# Summer Dress Ltd Elegance Orientale Ltd

23 April 2015

## Structural Inspection Report

# **Lateral Stability system of Office building**

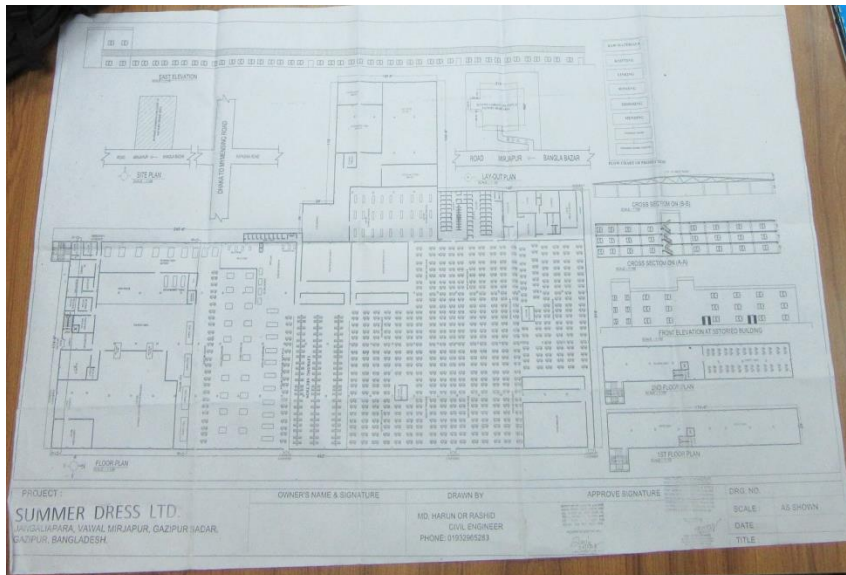
Building has 2 bays in short direction and 9 bays in long direction. The edge columns are 250mm x 500mm and orientated with the weak axis perpendicular to the short axis of the building. The ground floor height is 4.5m. This provides a weak lateral stability system for RC the building

- Structural engineer to review lateral stability system for the RC office building.
- Apply appropriate remedial measures if lateral stability found to be inadequate

# **Lack of structural drawings**

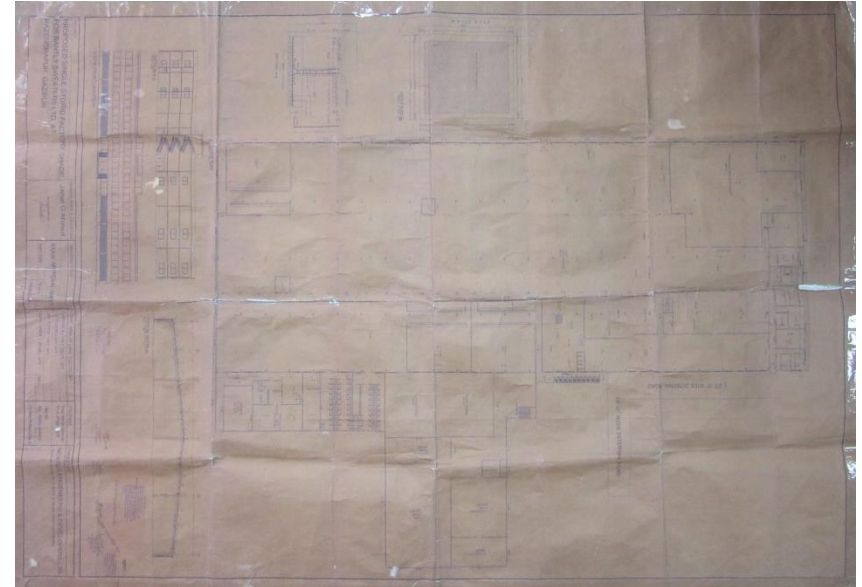
Except for what is shown on the Permit and Industrial Inspectorate drawings, no structural or architectural drawings were provided for Site survey visit

- Building engineer to collect information and produce accurate and complete as-built structural documentation for all buildings at soonest opportunity.

# **Discrepancies between drawings and site observations**

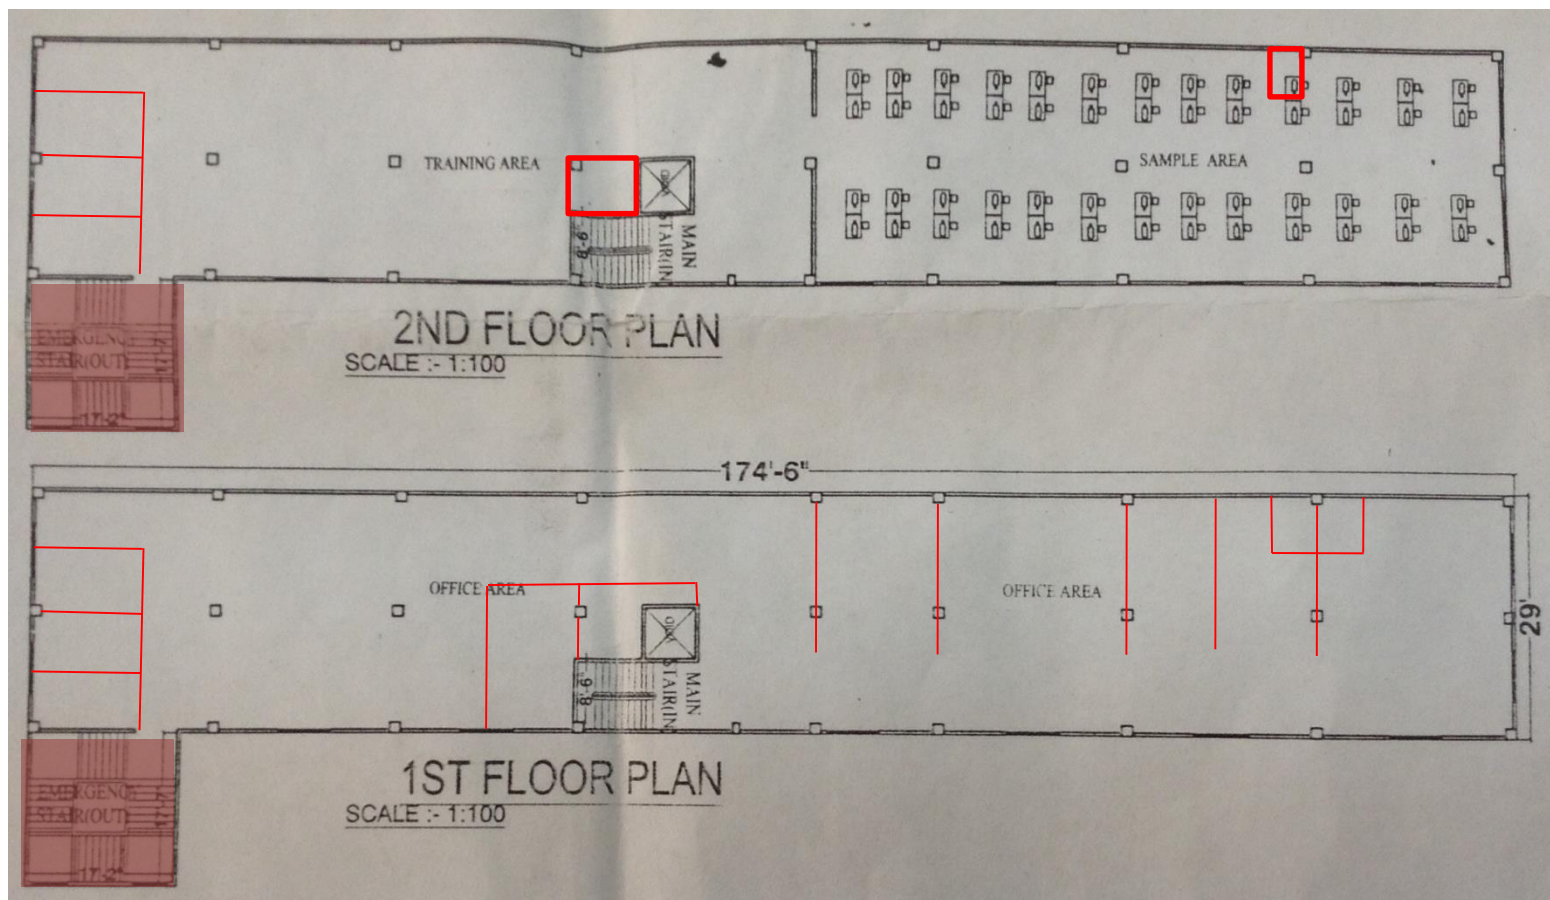
Grid dimensions are incorrect where shown on the Permit drawing  
 The shaded area shows an RC staircase that does not exist – a steel spiral stair has been erected in this location  
 Red lines indicate the walls which are not present in the permit drawing

- Building engineer modify permit drawings and re-submit showing actual layouts of buildings.

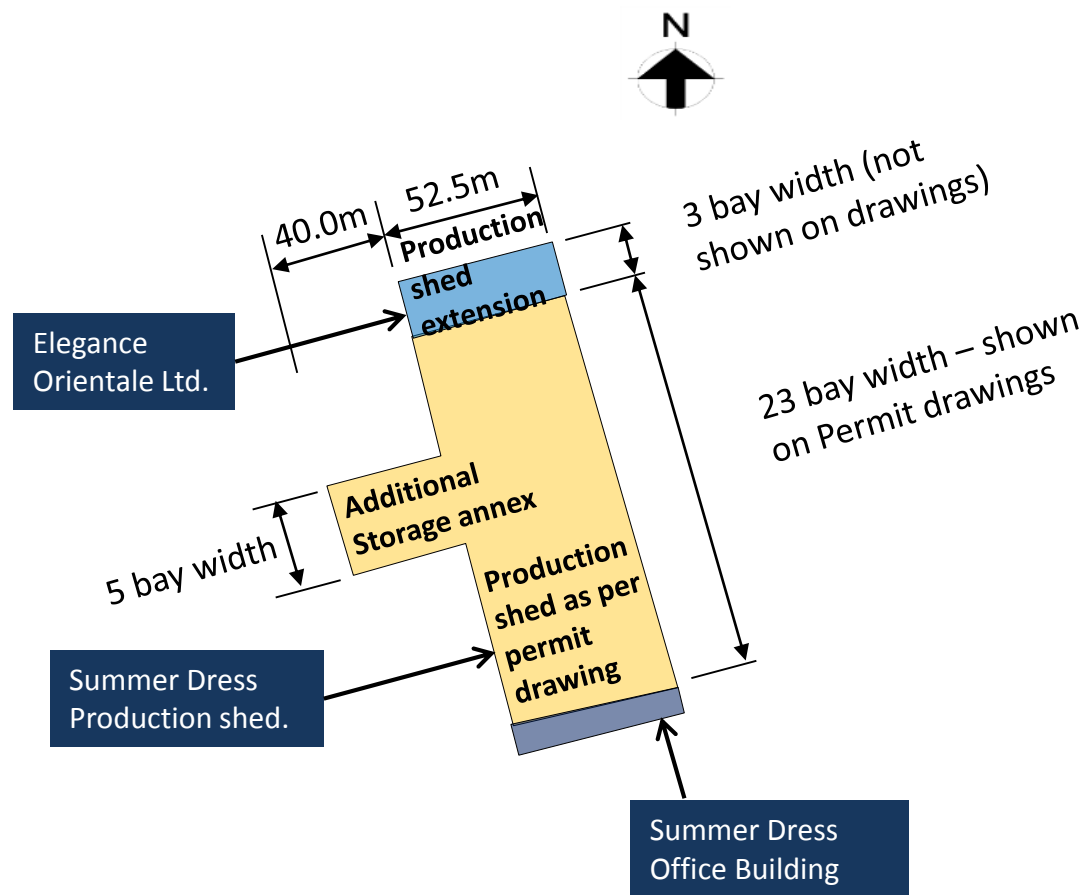
Permit drawings show a steel portal framed Production shed with 23 bays at 6.1m c/c; the shed observed on site has 26 bays at 6.1m c/c

# **No horizontal bracing of the portal structures**

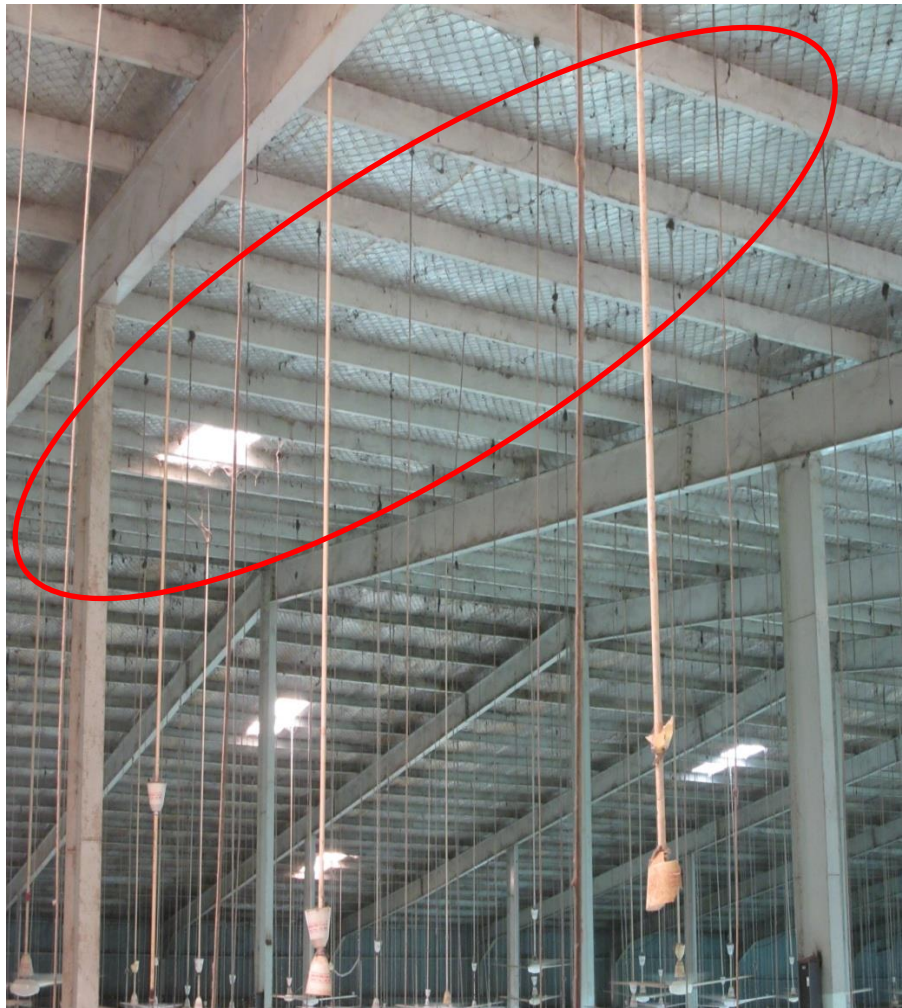
No horizontal roof bracing in any line of portals

No cross bracing from eaves of the steel portals to the top of the brick wall  
The steel column cleats welded onto them and built into the top of the 2.65m brick wall to provide lateral stability at this level.

- Structural engineer to review lateral bracing system for the Main production shed, and provide lateral bracing as appropriate.
- Document the bracing system on updated as-built drawings .
